This 1:200 scale adjacency plan (based on SoA v8.0), which identifies the extent and departmental relationships and reflects the operational requirements of the departments within the 3Ts Project, is confirmed as agreed by the Trust, subject to the following caveats:

PROJECT TITLE
Brighton 3Ts

DRAWING TITLE
Room Relationships - Security Kiosk - Level B1 Stage 1

DRAWING TITLE
Room Relationship: Discharge Lounge - ENT - Aud - MaxFax - Rheumatology: Level 1 Stage 1

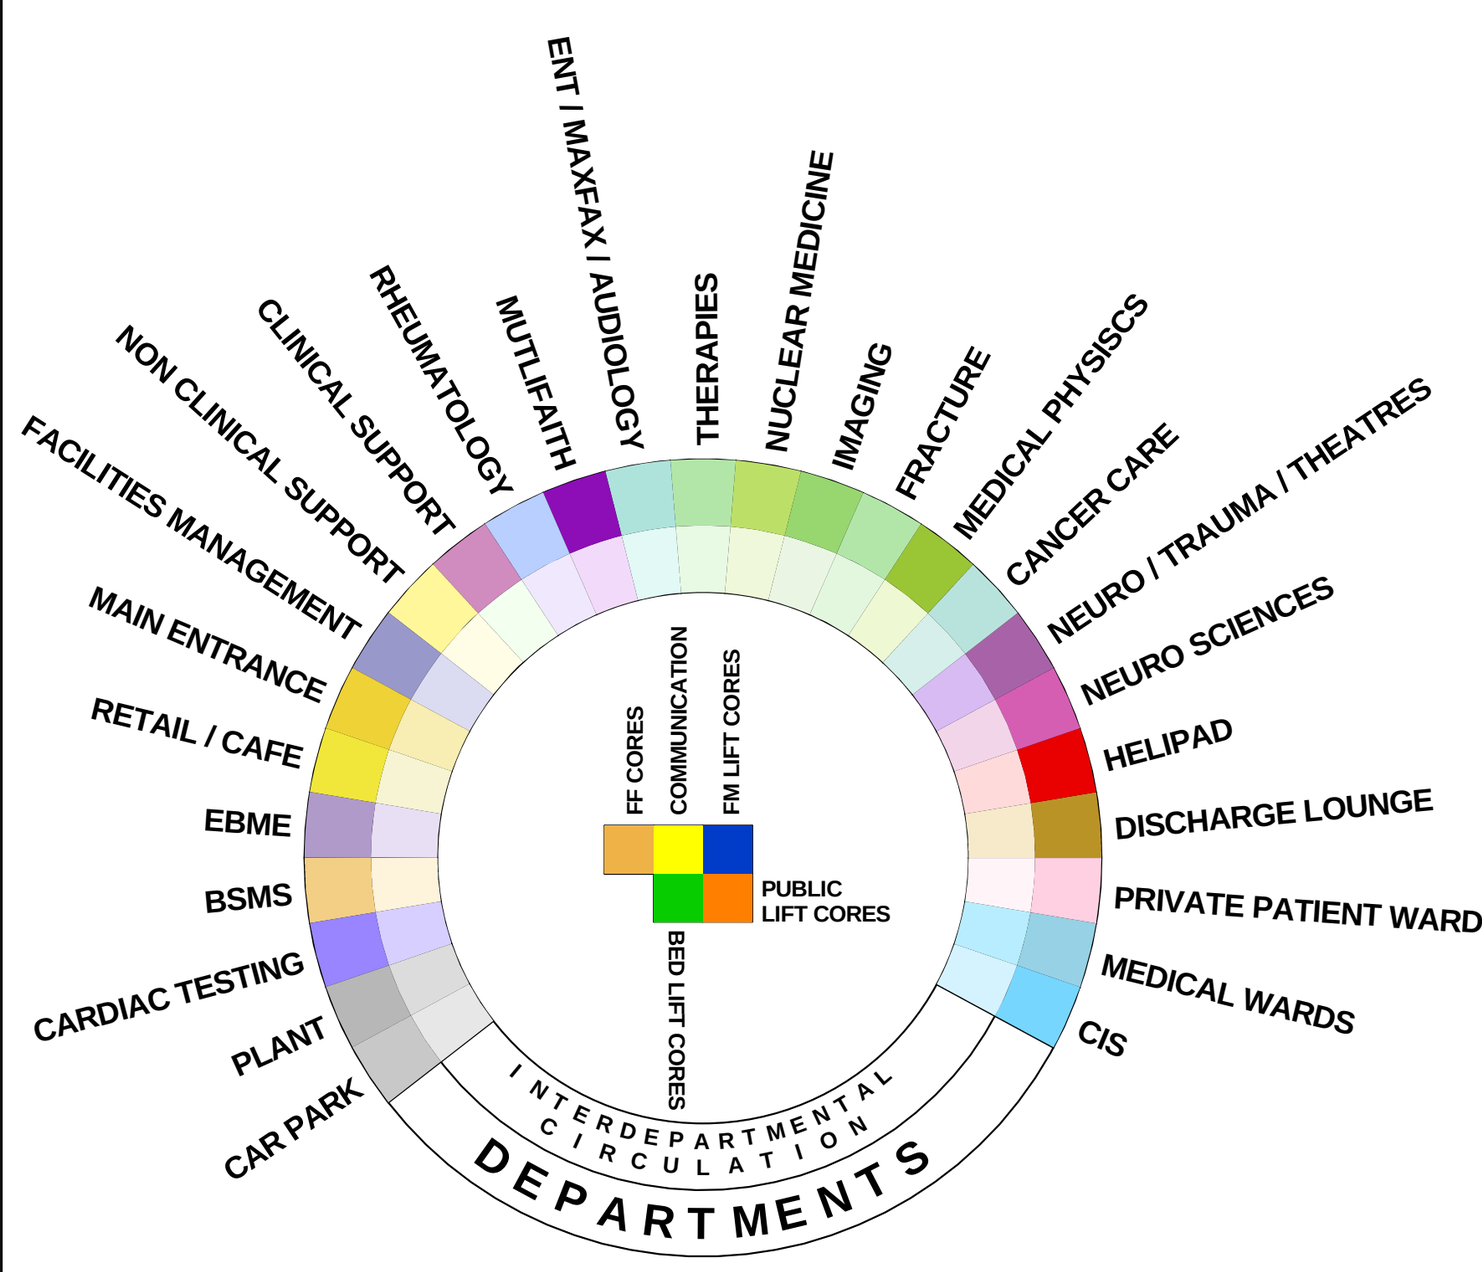
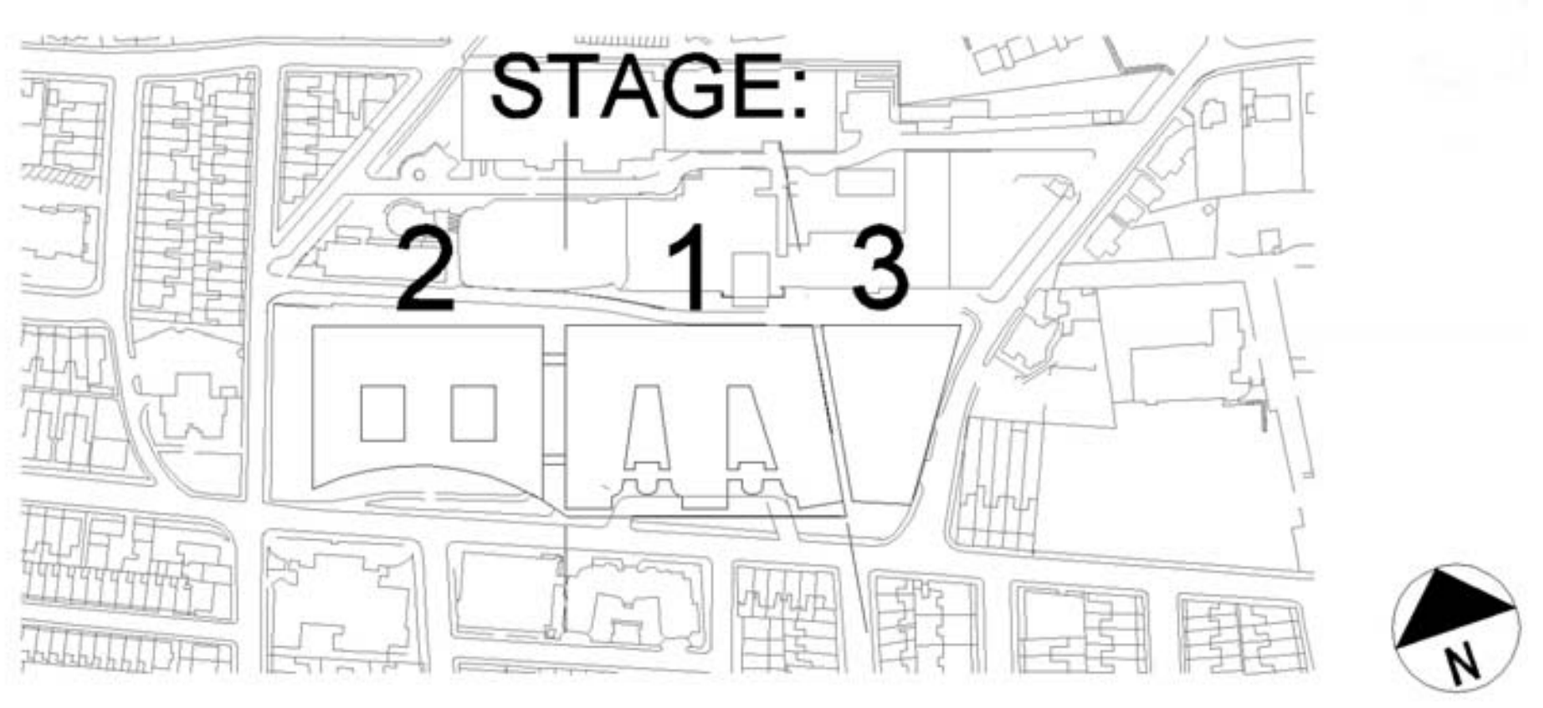
A Photocopier room added
